Docket Nos: 50-438
and 50-439

FACILITY: Bellefonte Nuclear Plant, Units 1 and 2

SUMMARY OF MEETING HELD ON AUGUST 20, 1976; TO DISCUSS TVA'S PROPOSAL TO RELIEVE THE REQUIREMENT FOR INSERVICE VOLUMETRIC INSPECTION OF HIGH-ENERGY FLUID SYSTEM PIPING ENCLOSED IN GUARD PIPES

TYPICAL PENETRATION WITH GUARD PIPE, BELLEVILLE NUCLEAR PLANT

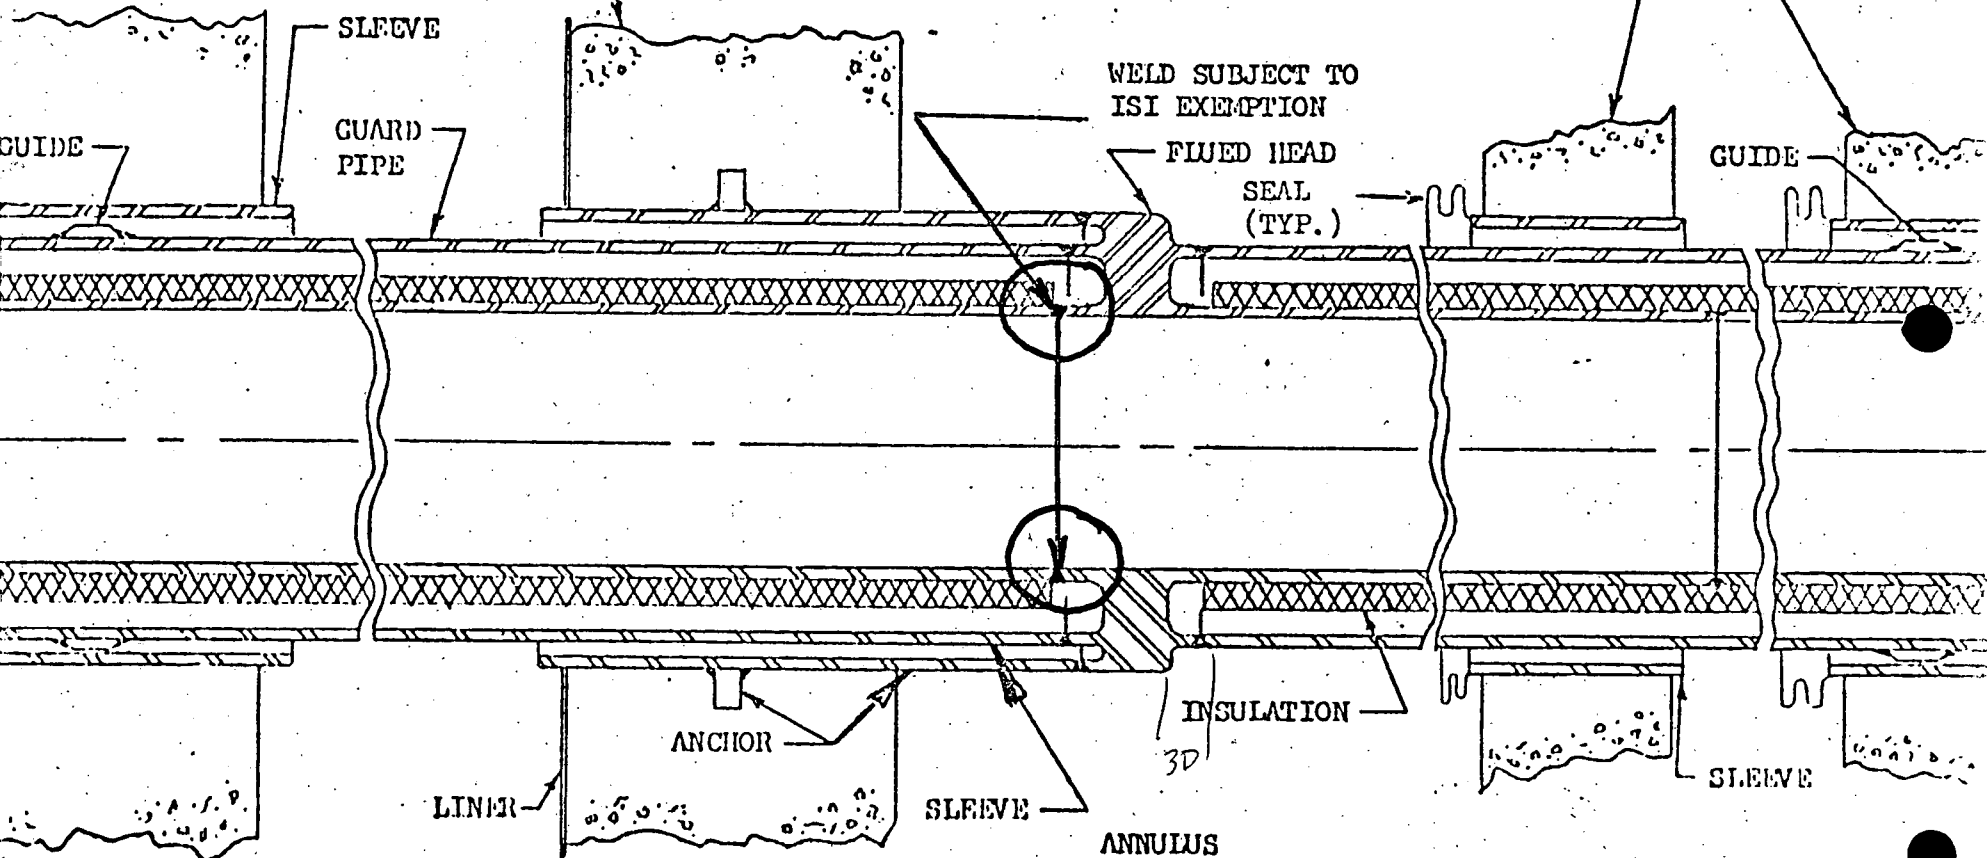
TVA stated that their pipe design would not allow inservice inspection unless many undesirable modifications are made. TVA feels that in the unlikely event of failure of the process pipe weld, the guard pipe will contain the forces associated with the event without failure of the guard pipe. We indicated that TVA would have to provide an analysis showing that the Bellefonte containment would not be violated if an uninspectable weld failed. TVA stated that they would provide such an analysis. Enclosure 2 contains a figure showing the particular weld for which TVA is requesting the exemption from inservice inspection.

We stated that TVA should include the following in their analysis:

1. Analyze for circumferential and longitudinal breaks at the process pipe forging interface weld. Include the dynamic loading effects on the guard pipe and analyze for the forces of the SSE plus dynamic loading of the break plus dead load. Be sure to also address jet impingement effects.
2. TVA must show that the guard pipe will not fail and as a minimum, that containment will remain intact.
3. A summary description of the analysis should be provided.

We stated that we must find TVA's analyses acceptable and that it must show that the Bellefonte containment will not fail before we would consider granting an exemption from inspection of these welds. TVA will inform us of the date they expect this analysis to be complete.
